**SUBJECT:** R-Area Groundwater (NBN) Biennial Effectiveness Monitoring Report in Support of R-Area Operable Unit (U) January 2021 through December 2022 (SRNS-RP-2023-00758, Revision 1, June 2024) and Savannah River Site's Responses to the Regulatory Comments on the Revision 0 Document, SEMS Number: 95

1. R-Area Groundwater (NBN) Biennial Effectiveness Monitoring Report in Support of R-Area Operable Unit (U) January 2021 through December 2022 (SRNS-RP-2023-00758, Revision 1, June 2024) SEMS Number 95
2. SRS Response to the U.S. Environmental Protection Agency's Comments on the R-Area Groundwater (NBN) Biennial Effectiveness Monitoring Report in Support of R-Area Operable Unit (U) January 2021 through December 2022, SEMS Number: 95, SRNS-RP-2023-00758, Revision 0, August 2023
3. SRS Responses to the South Carolina Department of Health and Environmental Control's Comments on the R-Area Groundwater (NBN) Biennial Effectiveness Monitoring Report in Support of R-Area Operable Unit (U) January 2021 through December 2022, SEMS Number: 95, SRNS-RP-2023-00758, Revision 0, August 2023

Revised Figure 4

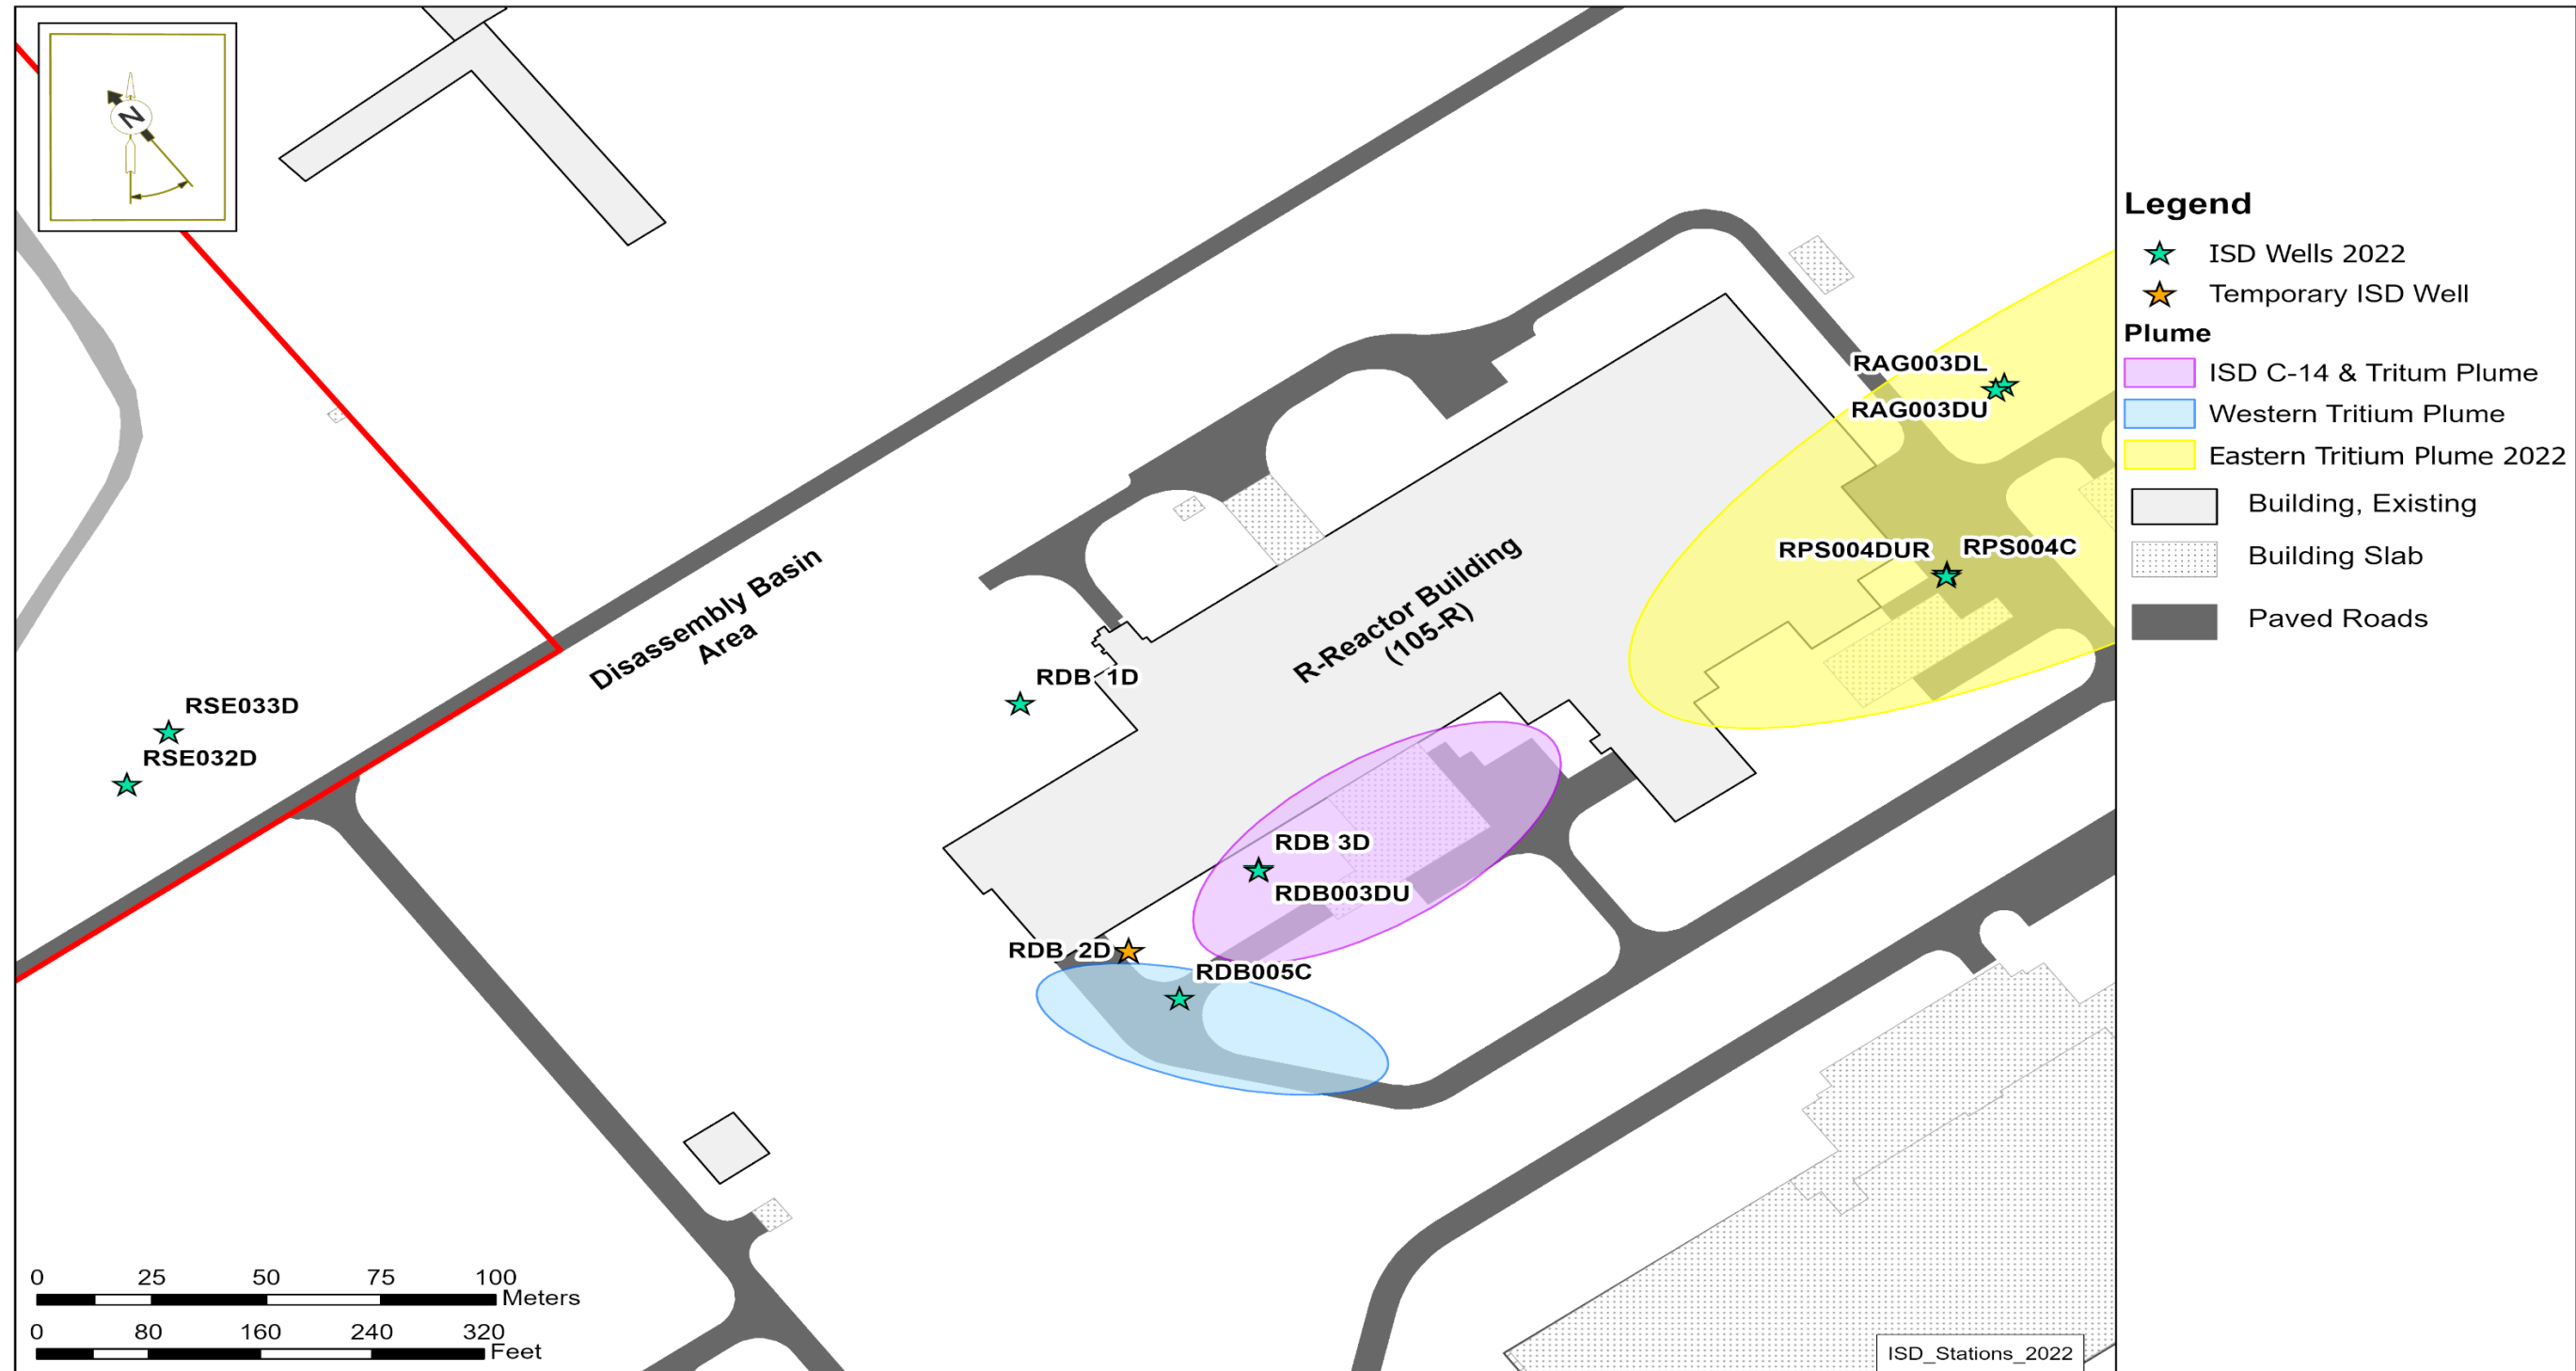
6. **Figure 4, ISD Monitoring Wells (2022), Page 22 of 40:** It is unclear why the Eastern Tritium Plume is not shown on the figure at RAG003DL/RAG003DU and RPS004C/RPS004DUR. *Please revise Figure 4 to include the Eastern Tritium plume.*

**Figure 4 has been revised to include the Eastern Tritium Plume (see attached).**

Revised Figure C-29

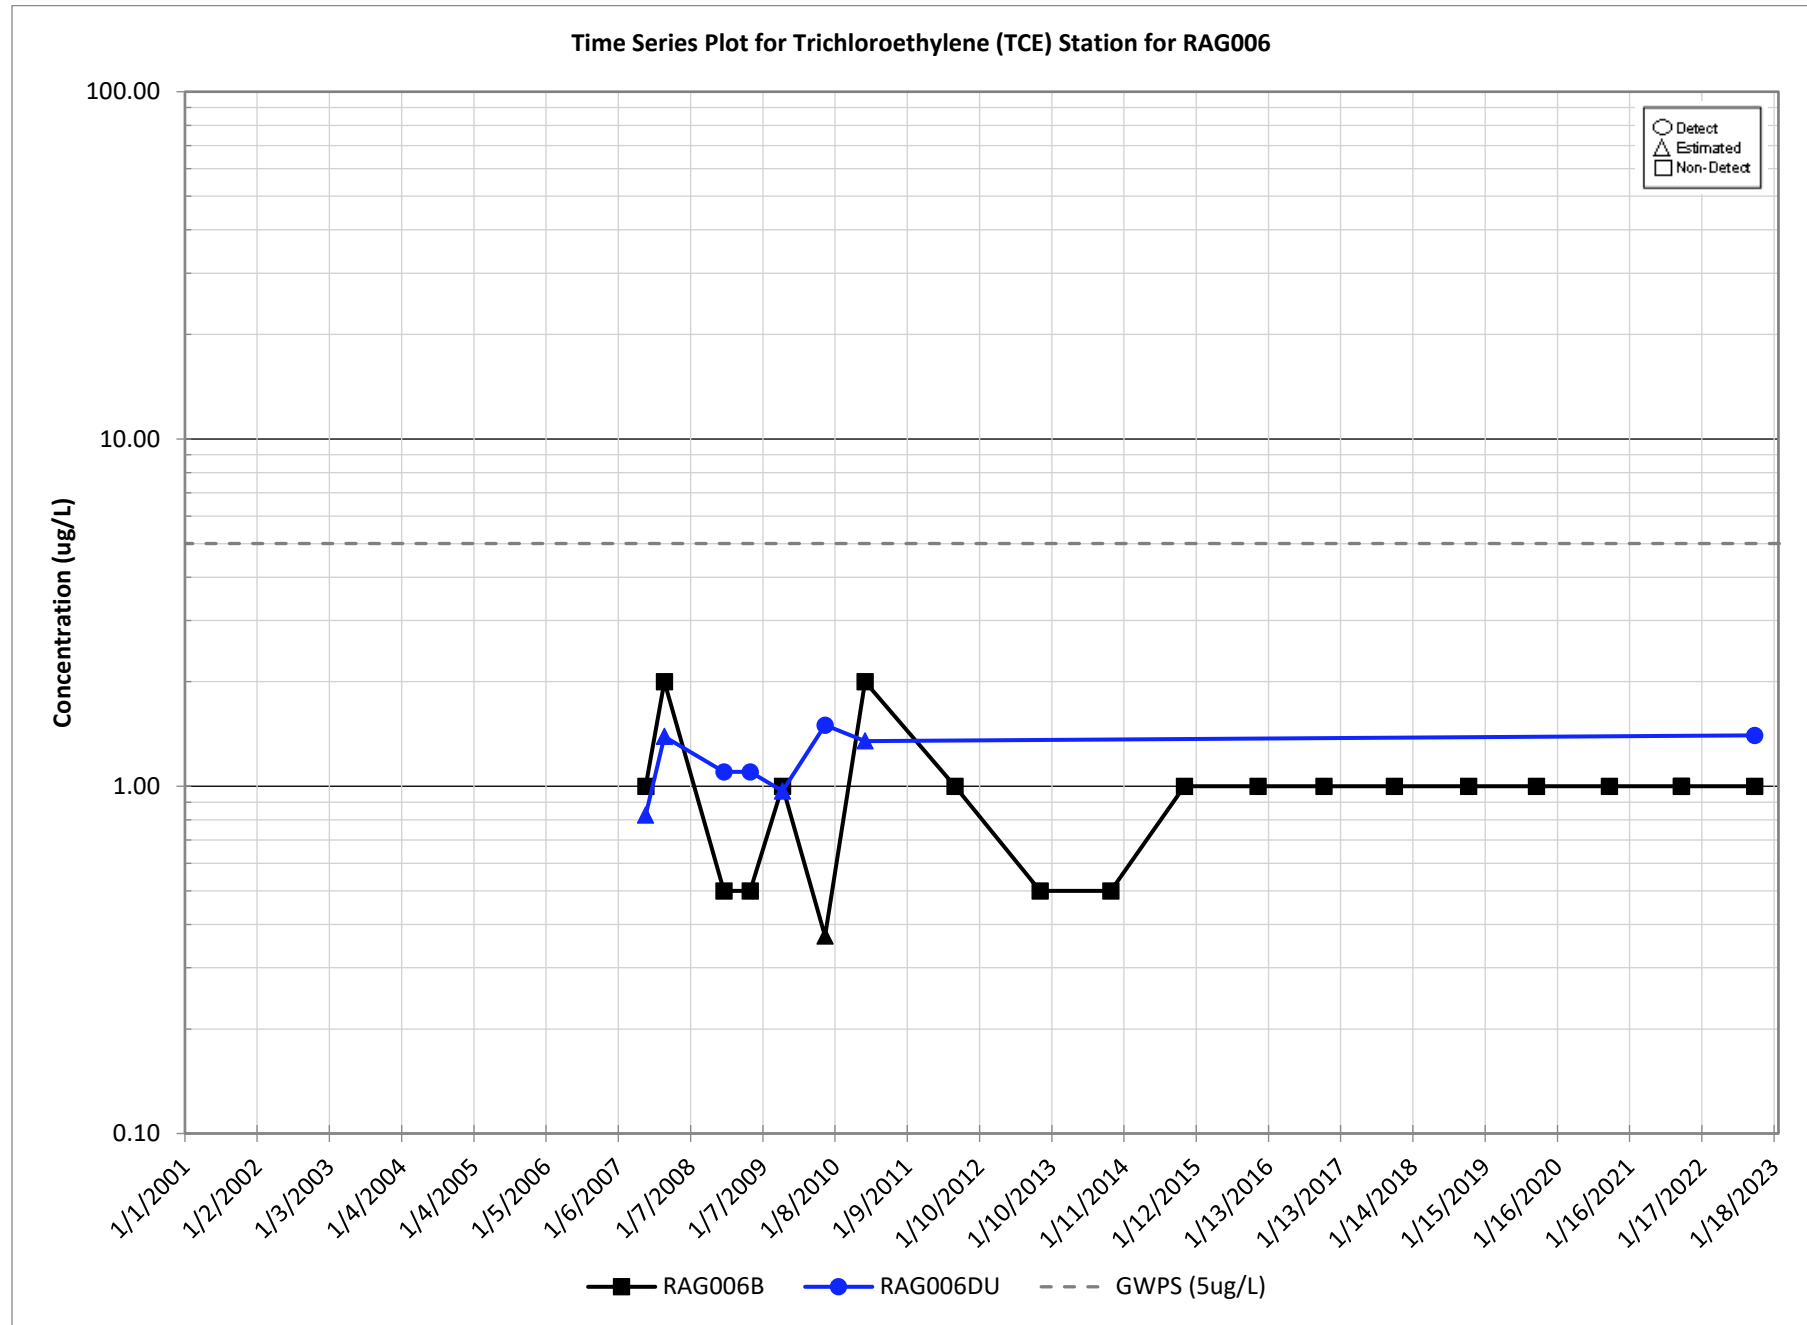
27. Appendix C, Time Series Plots. For time series plots of contaminants with an MCL, the legend includes a gray line showing the GWPS or MCL. The lines that are used are difficult to see and differentiate from the regular lines in the plot. Please change this to a large, dashed line or other more obvious marker for the MCL.

**The time series plots will be revised to show a thicker dashed line for the MCL or GWPS. The revised Figure C-29 (attached) is an example of how time series charts will look in the revised 2023 RAGW EMR.**

Revised Figure E-1

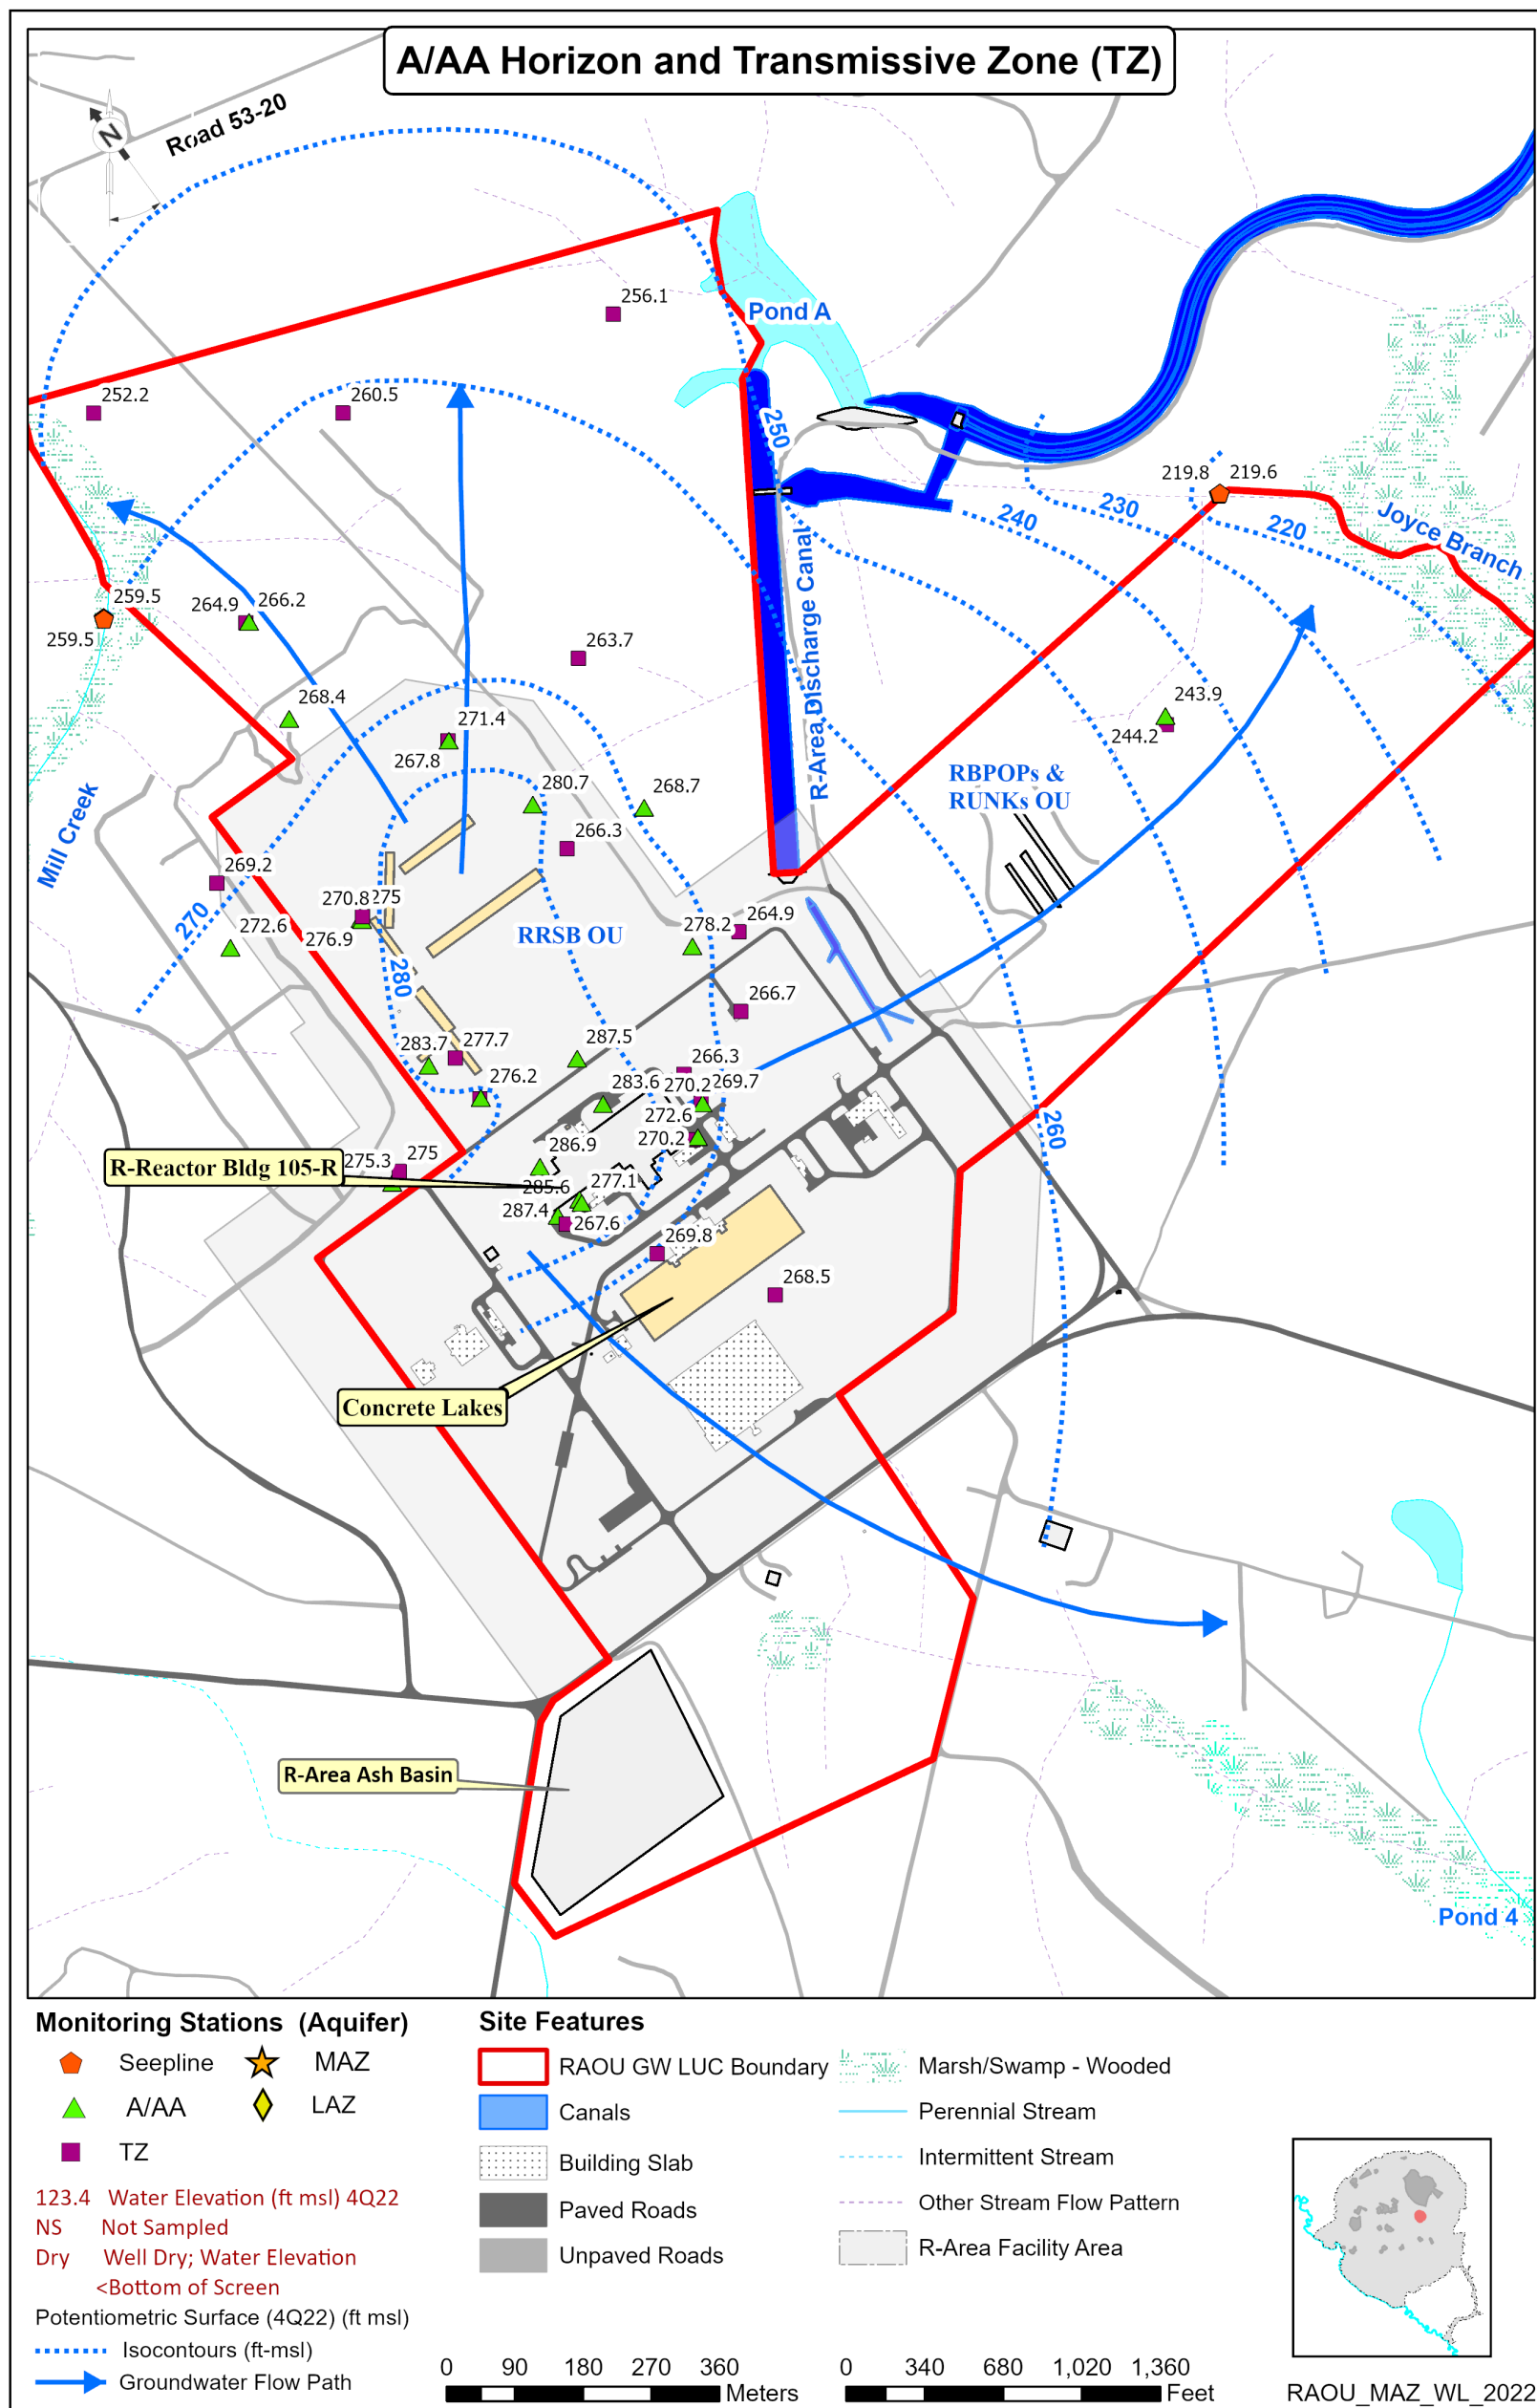
- c. Figure E-1, R-Area TZ Well Water Elevations 2022, page E-3. Please see the following comments.
- i. Multiple TZ wells are marked with orange squares, but the legend indicates that purple squares represent TZ wells.

- vi. The groundwater elevation contour intervals used in the figure are inconsistent and the figure should be revised with consistent intervals. The figure includes the following contours in ft amsl: 285, 280, 270, 265, 260, 250. Please revise the figures to include consistent 5-ft or 10-ft contour intervals.

- ix. The potentiometric contours are inaccurate based on the groundwater elevations and well locations presented on the figure, and over half of the monitoring points on the figure are not within the correct contours. Please re-draw the contours to reflect the groundwater elevations measured in 2022.

**The orange squares will be replaced with purple squares on the figure to correspond to the legend.**

**Figure E-1 (attached) will be corrected to show red pentagons for the seepage wells.**

**This is primarily an issue with Figure E-1, which has many wells close together. The revised Figure E-1 has minimized the overlapping of water elevations on the station symbol, including rounding all water elevations to 1 decimal place to make more room for symbols.**

**The revised figures all have 10-ft contour intervals for consistency.**

**Where two wells are co-located or nearly co-located, preference is given to the greater of the two potentiometric elevations. It is recognized that the 280 ft-amsl contour is incorrectly drawn and will be corrected in the revised Figure E-1 (attached). The 285 ft-amsl contour will be removed to display only 10 ft contour intervals.**
